April 8, 1986

Haddam Neck Plant

Additional Information for Fire Protection Scheduler Exemption Request

SKETCH NO. 2

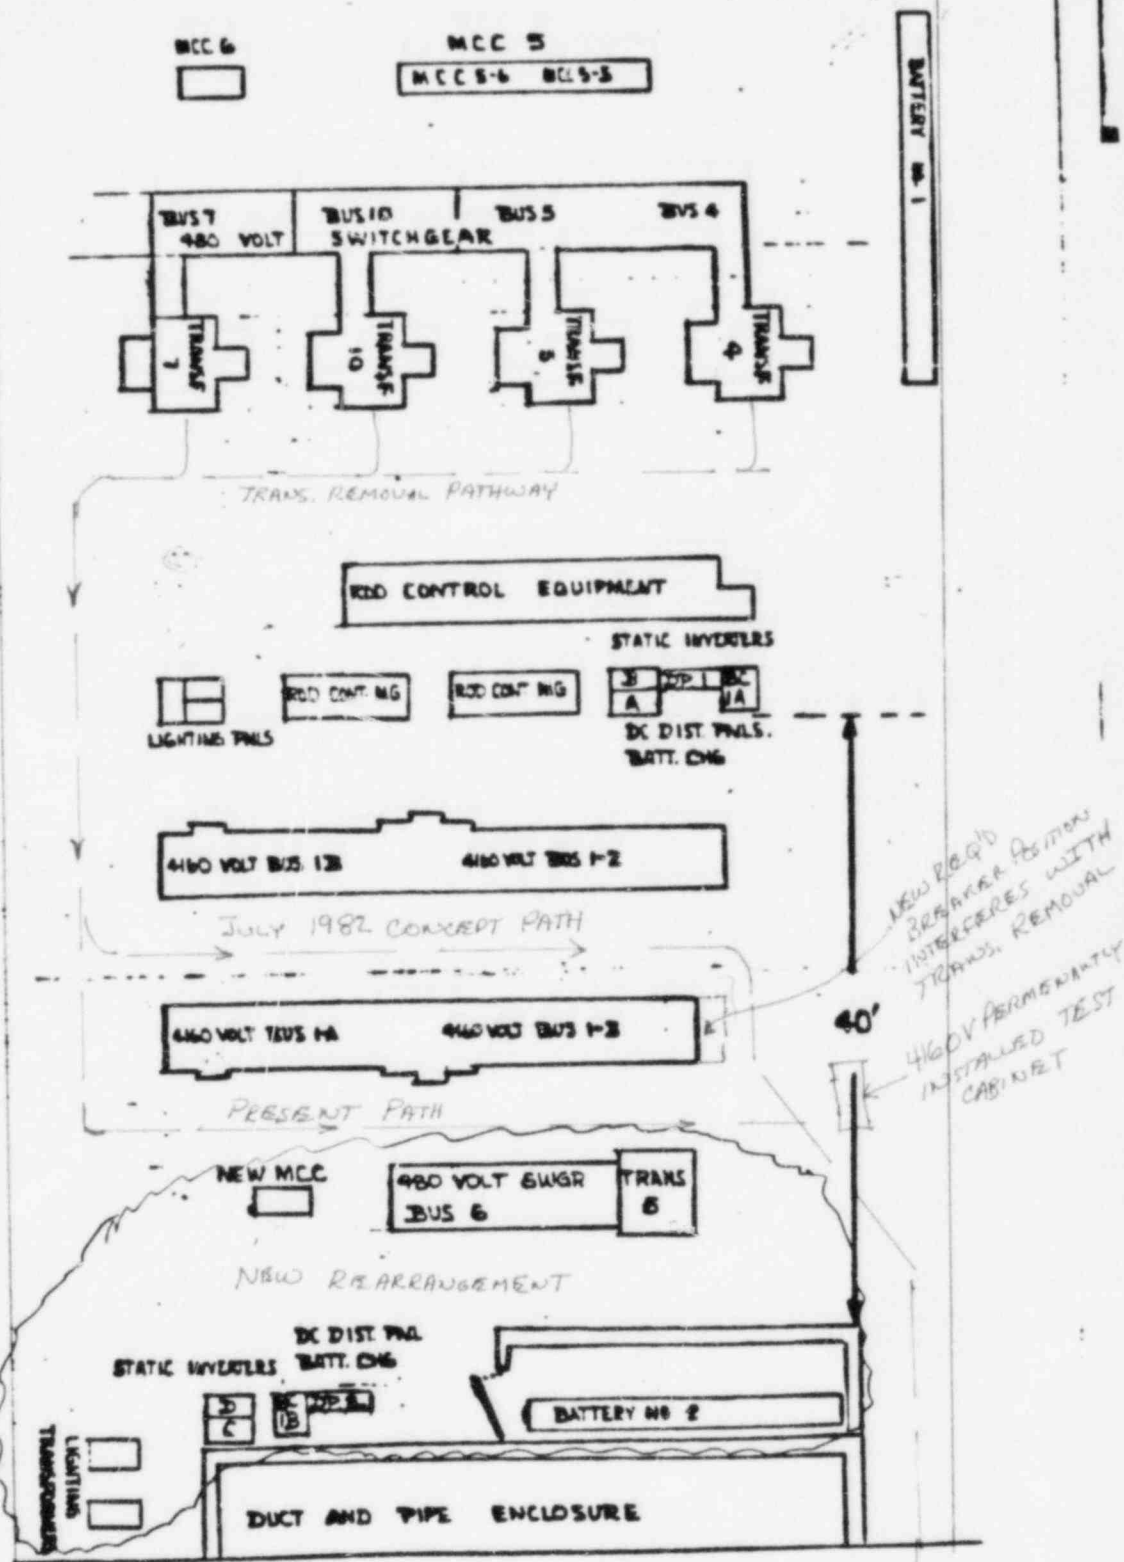
On July 16, 1982, CYAPCO submitted a supplement to our March submittal. A major switchgear room re-arrangement was proposed, that arrangement being conceptually depicted on Sketch SKRBAT0605822 of the report. A copy of the arrangement sketch is included as Attachment 3 in a marked-up form. It is appropriate to reflect on the level of detail of CYAPCO's conceptual/preliminary reviews conducted before arriving at a suitable confidence level to be able to propose the re-arrangement depicted on that sketch, as follows:

- o The free space at the South end of Fire Area S-2 was sufficiently sized to contain the equipment depicted. 480 volt LCC transformer removal requirements were reviewed to the extent that a removal path (as marked on Attachment 3) would be available, but that control switch handles on the faces of 4160 volt breaker compartments would need to be removed to allow transformer passage. The free space was in excess of the required 20 foot separation from redundant Appendix R credited equipment, however many intervening combustibles, primarily cabling, existed. These were identified and fixes proposed in the July 16, 1982 Fire Area S-2 exemption request.

- o The spare breaker position in 4160 volt bus 1-3 was assigned to power a new 4160 volt load for the backfeed of the spare main generator step-up transformer. To now accommodate the planned rearrangement, a breaker position would need to be added to the single remaining space at the east end of 4160 volt bus 1-3. With this breaker in place, it would now be impossible to remove the 480 volt LCC transformers intact, i.e., without major disassembly by cutting of steel plate members. The transformers also could no longer traverse the original intended removal path since the new switchgear arrangement now blocked that path; therefore, no provision to remove the transformers could be identified.

BUS 7 LOADS ARE NOT REQUIRED FOR A FIRE IN THIS AREA. RELOCATED BUS 6 SERVES DIVISION B UNDER THESE CIRCUMSTANCES.

MCC 5 CAN RECEIVE POWER FROM EITHER DIVISION A OR DIVISION B THEREFORE IT IS COLORED YELLOW. AFTER THE PROPOSED MODIFICATIONS ONLY DIVISION A (RED) SAFE SHUTDOWN LOADS WILL BE POWERED FROM MCC 5.
